PLANNING, ZONING, & BUILDING DEPARTMENT
PZ&B Staff Combination Memorandum: Architectural Commission and Town Council

SUBJECT: ARC-24-0011 (ZON-24-0006) 1741 S OCEAN BLVD (COMBO)

MEETING: JUNE 26, 2024, ARCOM
JULY 10, 2024, TC

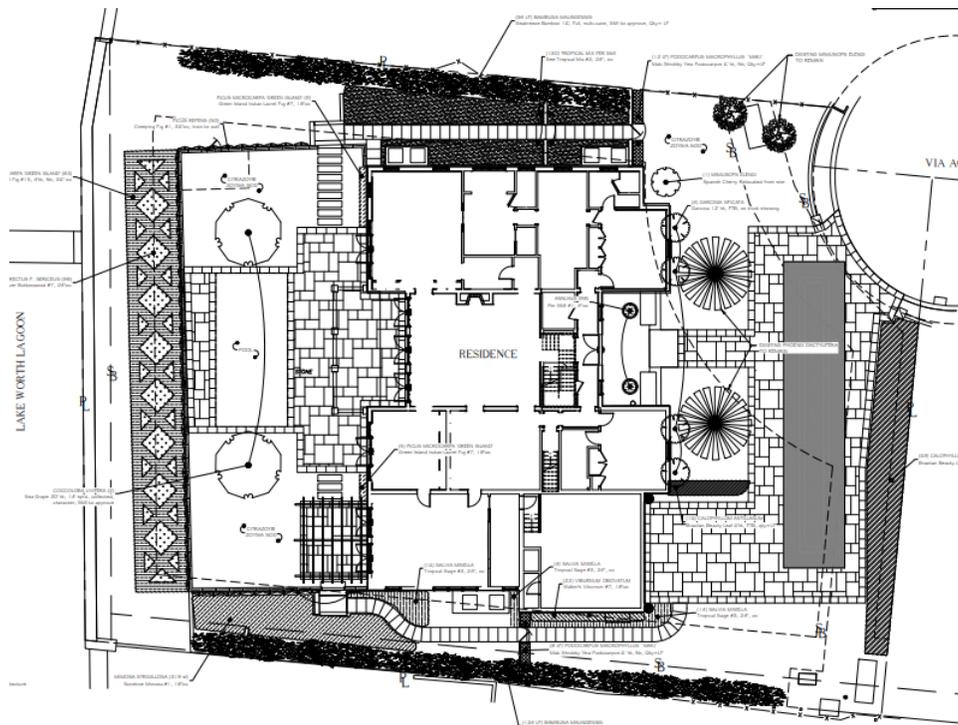
The applicant is proposing modifications and additions to this existing Palm Beach Regency style single family residence. The property is located along the intracoastal waterway at the west terminus of Via Agape. The new addition centers the second floor and is in keeping with the existing architectural style. Window and door modifications will result in more classical proportions and the rear yard will see a reduction in pool size from 50' x22' to 32' x 15'. Finishes are consistent with the existing house including smooth stucco and multi-lite windows.

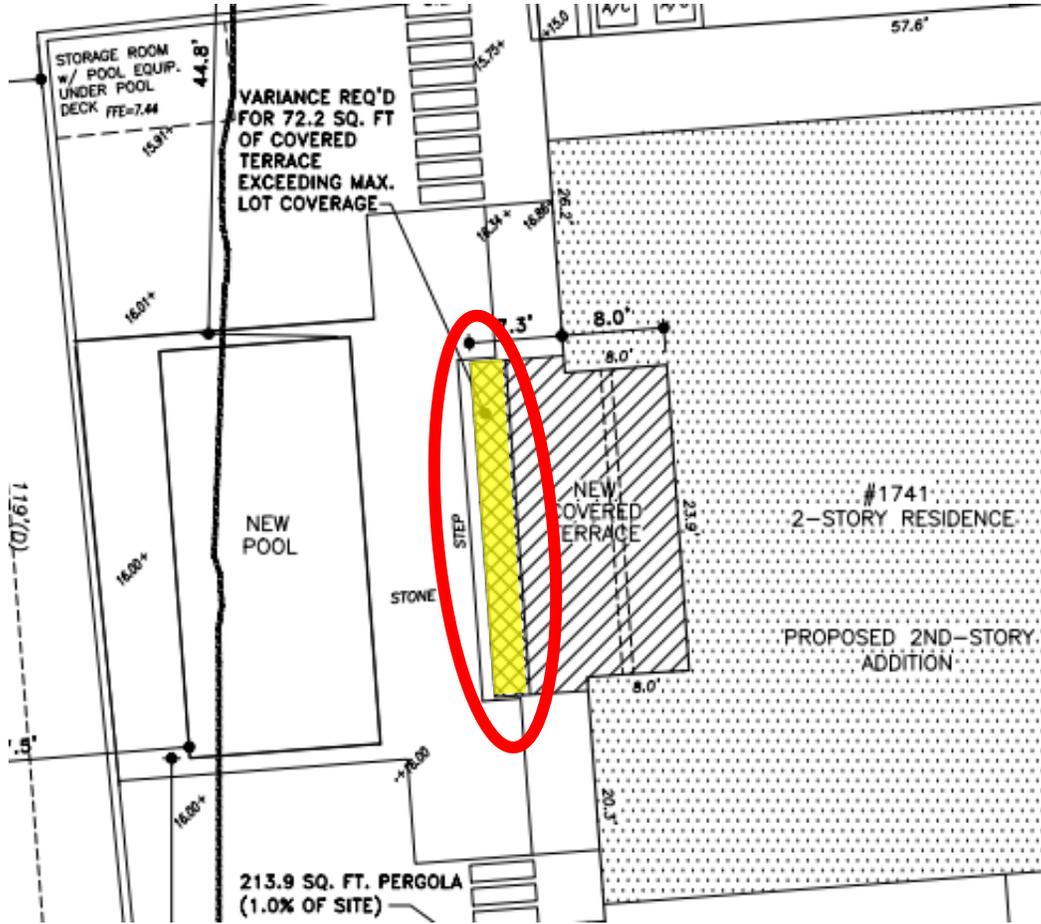
A preliminary review of the project indicates that the application, as proposed, is inconsistent with the Town zoning code and requires four (4) variances, most of them related to legal non-conforming conditions that will remain after 50% or more of the existing structure is impacted through this project. Some situations such as the landscaped open space are improving by approximately 6% yet are still shy of the required 50% currently in the code.

Variance #1 is being requested for the new terrace at the rear of the property to exceed the lot coverage by approximately 72 SF. Variances 2-4 are to retain existing conditions.
